STAFF REPORT
(Preliminary Plat)

CASE NUMBER: S/D 88-15 - BEACON VILLAGE
OWNER/APPLICANT: Leewood Homes, Inc., 6130 Legion, Wichita, KS 67204
SURVEYOR/ENGINEER: Bill Yung Design
LOCATION: North of 21st Street North and east of Oliver.
SITE SIZE: 40.4 Acres
NUMBER OF LOTS:
Residential: 131
Office:
Commercial:
Industrial:
Total: 131
MINIMUM LOT AREA: 8,400 Sq. Ft.
CURRENT ZONING: "AA"
PROPOSED ZONING: "AA"

Re: Preliminary Plat S/D 88-15 - BEACON VILLAGE

STAFF REPORT
(Revised Preliminary Plat
Previous Final Approval 5/12/88)

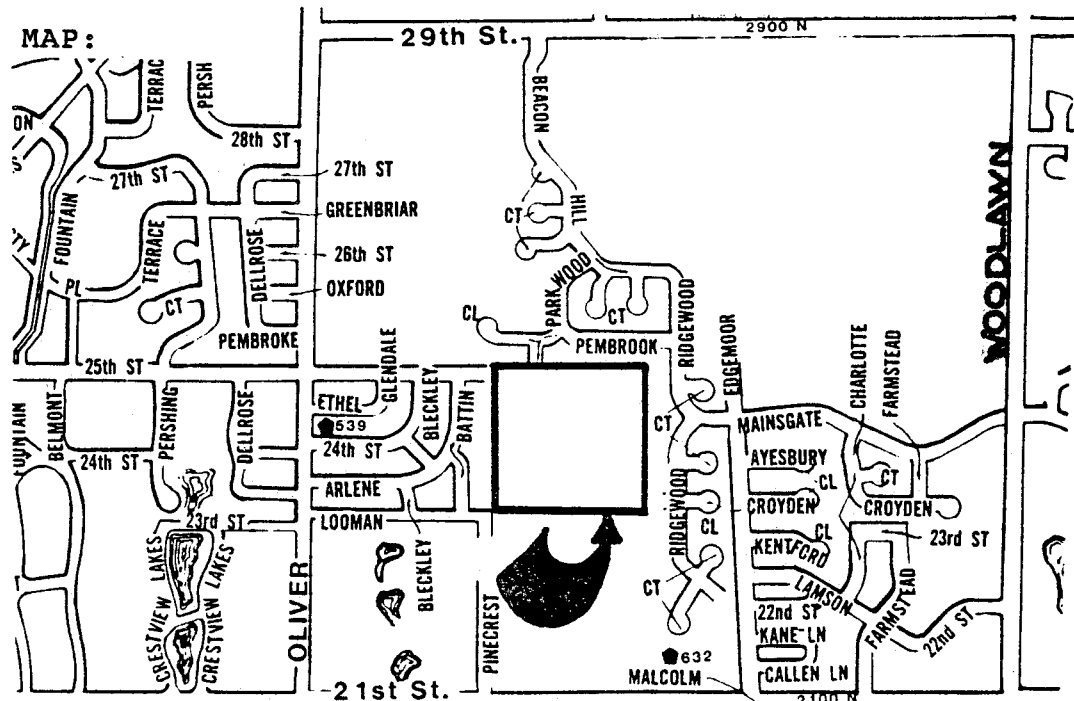
NOTE: This is a revised preliminary plat of a previous plat approved by MAPC on May 12, 1988. Changes include increasing the number of lots from 131 to 150 and reducing the minimum lot area from 8,400 sq. ft. to 6,784 sq. ft.

- I. The final plat shall clearly indicate that a 20-foot building setback and utility easement are being platted for all the lots in Block 6. For Lots 1, 2 and 3, Block 7, a 25-foot building setback shall be indicated from Beacon Hill.

- M. On the final plat, Pinecrest Street at the southwest corner of the plat shall be labeled and 30-feet of half street right-of-way shall be dedicated for Pinecrest at this location.

- N. The final plat tracing shall indicate a 10-foot utility easement centered on the lot lines common to Lots 19 and 20, Block 6.
- O. The applicant's engineer is advised that the Register of Deeds is requiring the name(s) of the notary public, who acknowledges the signature on this plat, to be printed beneath the notary's signature.
